FACTORY SERVICE BULLETINS

These suggestions and solutions for technical problems come from service bulletins published by Mercedes-Benz, selected and adapted for independent repair shops.

Installing interference suppression filters, engine 104

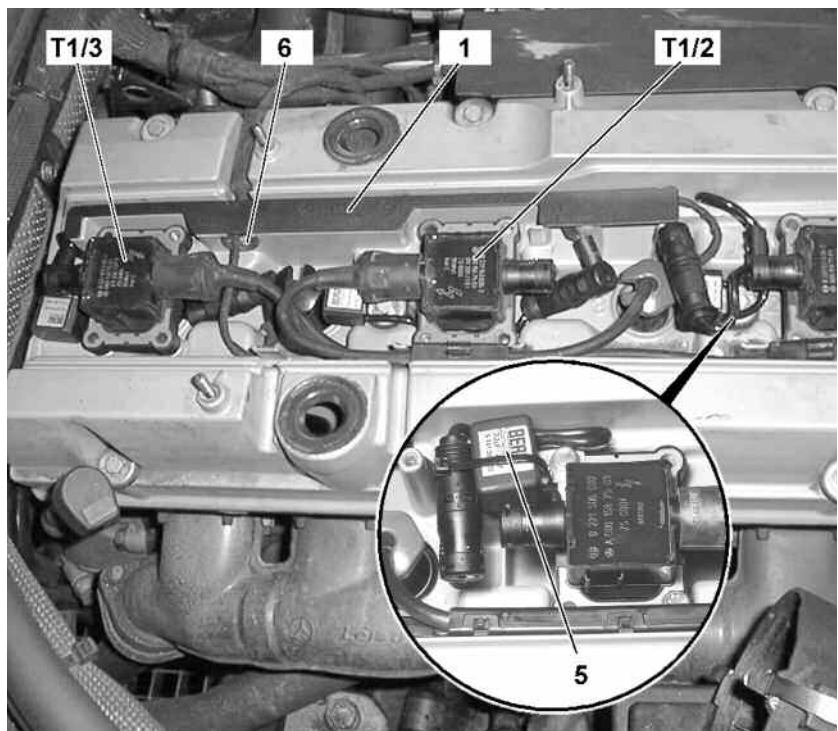
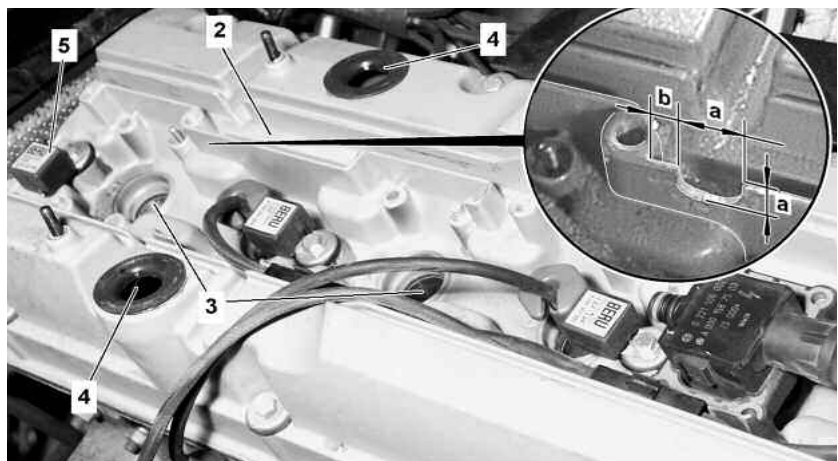
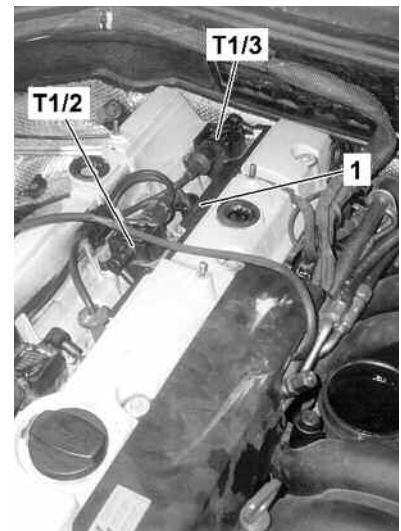
Sometimes the only way to quiet a radio is with ignition suppression capacitors or filters. To install ignition interference suppression filters, first remove the intake air pipe and the ignition wire shaft cover. Then remove the ignition coils T1/2 and T1/3. Next remove cover 1 and remove the wires from the cable shaft (2). Plug the openings in the valve cover (3 and 4), before you cut out sections in the cable shaft wall. Dimension *a* is 10 mm; dimension *b* is 7 mm. Install

the interference suppressors (5).

Re-install the ignition coils and connect the interference suppressors in the circuit 1 feed lines for the ignition coils. Route the electrical lead for ignition coil T1/3 through the cutout you made with a protective sleeve. Make sure the leads for the interference suppressors for both coil T1/2 and T1/3 are below the ignition coils, but do not pinch the wires. Finally, re-install the cover, the ignition cable shaft cover and the air intake pipe.
